**RE: BLOCK 21**

I reviewed the drawings, and evaluated the site context. My comments on the plans and elevations for this project are as follows:

**East Third Avenue Facades Massing Comparison**

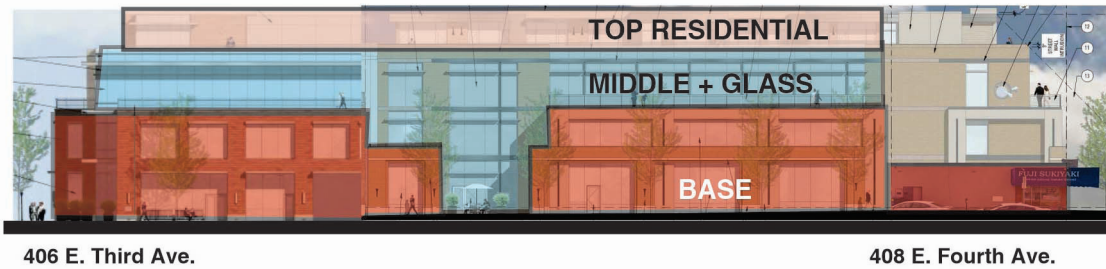
1. In their study session, several commissioners expressed concern about the large amount of glass on the office portion of the project.
2. The setback between the second and third floors is much less than the two adjacent projects fronting South Claremont Street, and substantially changes the massing of the project relative to them - see comparative wall section and massing diagrams below. That, along with the absence of any pedestrian scale canopies or awnings, would result in a rather monumental feel at the pedestrian level.

2. Add a projecting cornice or roof canopy at the second level to emphasize the two story massing along street frontages to better relate to the adjacent new projects and the pedestrian scale of the sidewalks. At the planning commission's discretion, the third floor could also be setback to reduce its impact on the overall building massing and the human scale of adjacent pedestrians.

**This shows passive open space while sketches show active space which is it?**

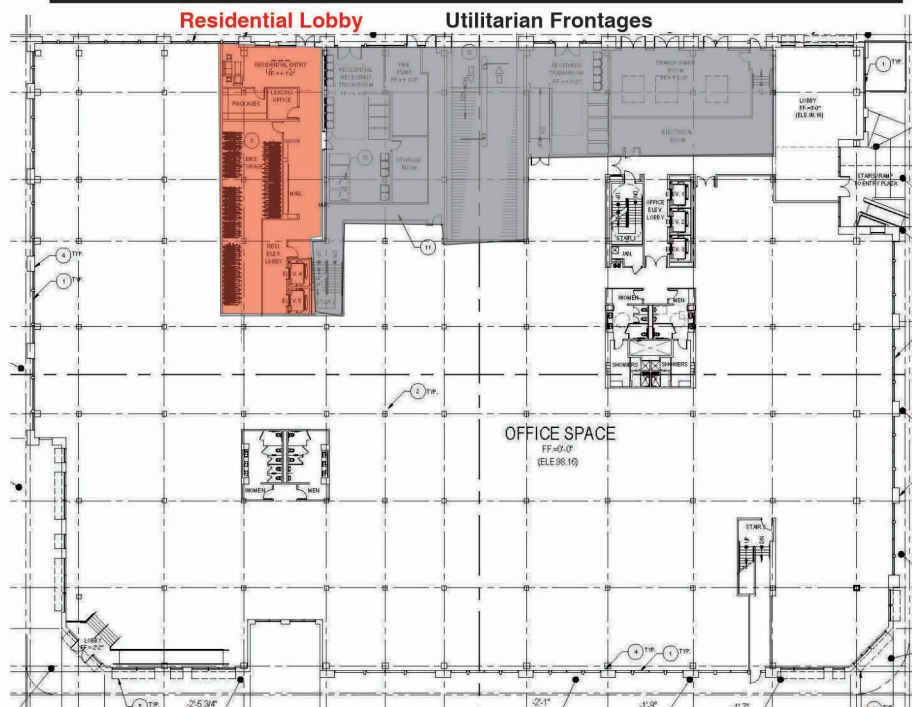
- The landscape plan shows a well landscape corner plaza adjacent to the main office lobby, while the sketches appear to show a more active use.

3. Clarify the intent for use and landscaping for the plaza adjacent to the office entry.
4. Provide street front awnings or canopies to better relate to the adjacent pedestrian areas.
5. Extend the darker wall facade with recessed window up to the sixth floor consistently around all facades.
6. Reduce the depth of the projecting private balconies to better integrate them into the overall design, wherever possible. This is often achieved by inseting the balconies, as shown on the photo below, or adding area to the common residential open space.

**Residential Lobby location on utilities frontage less than desirable**

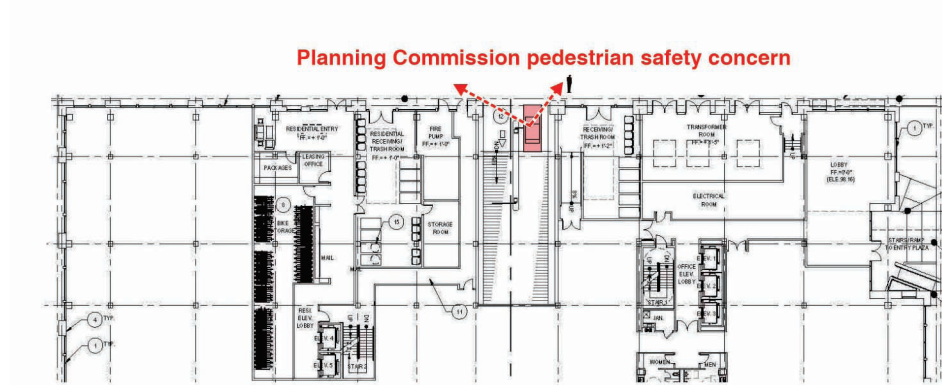
4. Planning commissioners' initial reaction was that they liked the design, but that it seemed a little overbearing and cold. They also were concerned that the design was lacking in overall design unity, and might not relate well to either the adjacent new developments or the adjacent neighborhood.
5. The project's residential lobby entry is located on South Claremont Street, adjacent to all of the building's utilitarian spaces and garage entry. This doesn't seem like a very pleasant lobby location, and not one to be thought of as a prestigious address.

7. Add a projecting roof canopy to the residential portion of the structure.
8. Reverse the color tones of the second and third floor masses to give more visual emphasis to the two story mass
9. Consider relocation the residential lobby entry away from the garage entry and adjacent utilitarian frontages.

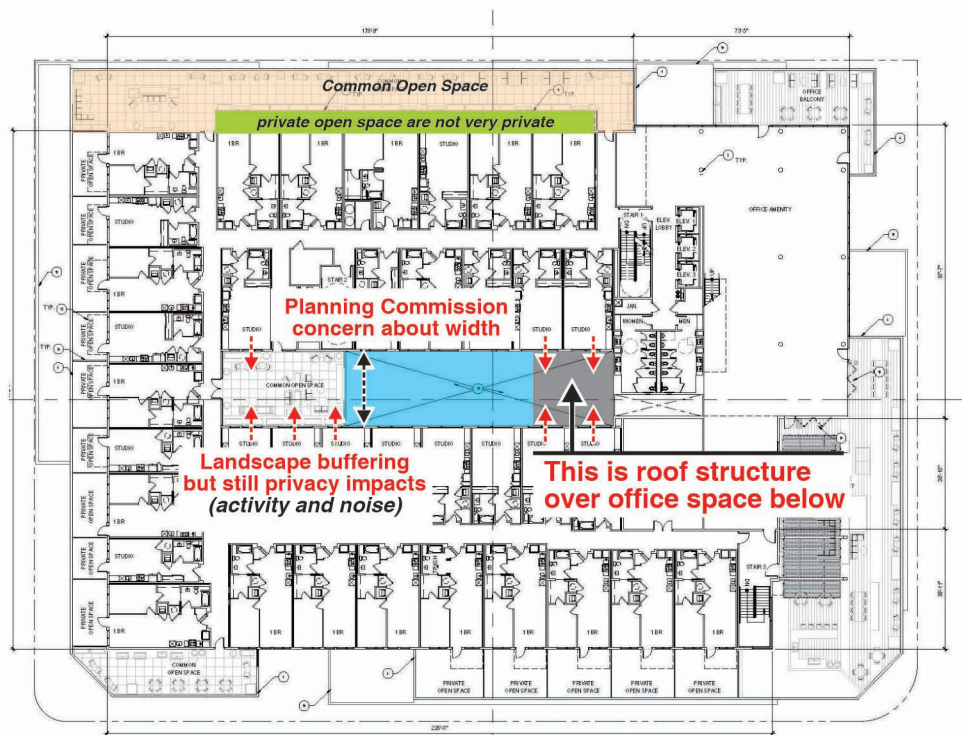
6. The residential balconies are quite deep for this type of project, and add to the lack of visual unity expressed by the commission.
7. The planning commission expressed concern for pedestrian safety related to the garage entry and exit ramp, a condition that might be compounded by the adjacent location of the residential lobby.

8. At least one planning commissioner expressed concern about the width of the open atrium on the residential floors. There is one other issue related to the residential common open space adjacent to the atrium. While the landscape plan shows plantings around the edge of the space to provide some visual buffering of the adjacent residential units, there may still be issues of visual privacy and noise, Note that the plan drawing failed to show the office roof structure that intrudes into the atrium space shown.

10. Resolve the privacy and landscaping of the spaces adjacent to the open atrium on the fourth floor.
11. Reevaluate the mix of residential common open space and private open spaces. One option would be to move this common open space to the roof, where the code allows, which is becoming quite common on larger residential projects.

13. Study the potential pedestrian/vehicle safety conflict at the garage entry.

**SOUTH DELAWARE STREET FACADE AS PROPOSED**

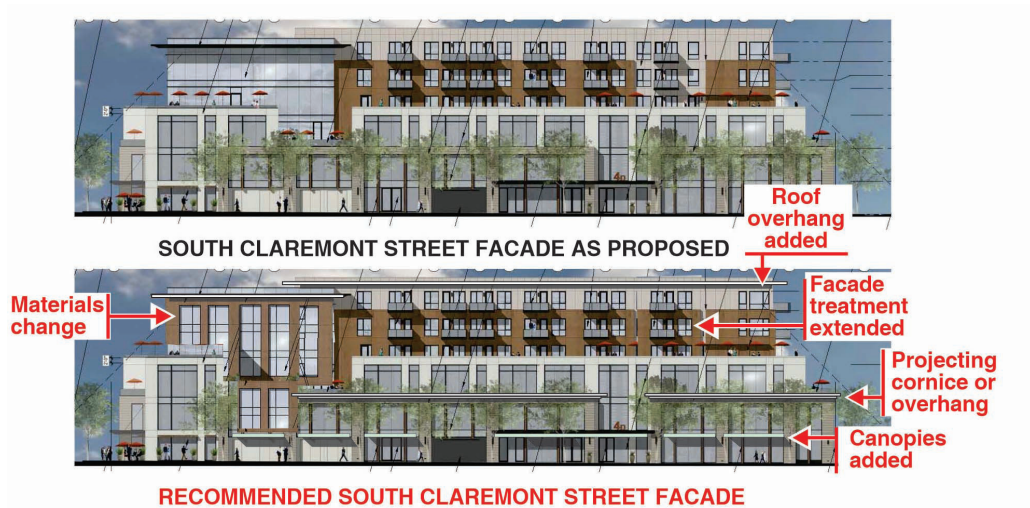
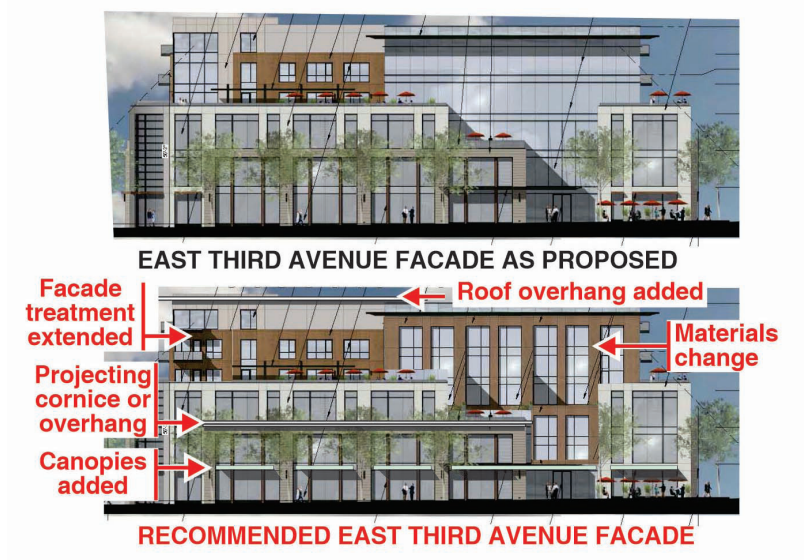
RECOMMENDED CHANGES SHOWN IN THE COMPARATIVE ELEVATIONS BELOW.

**RECOMMENDED SOUTH DELAWARE STREET FACADE**
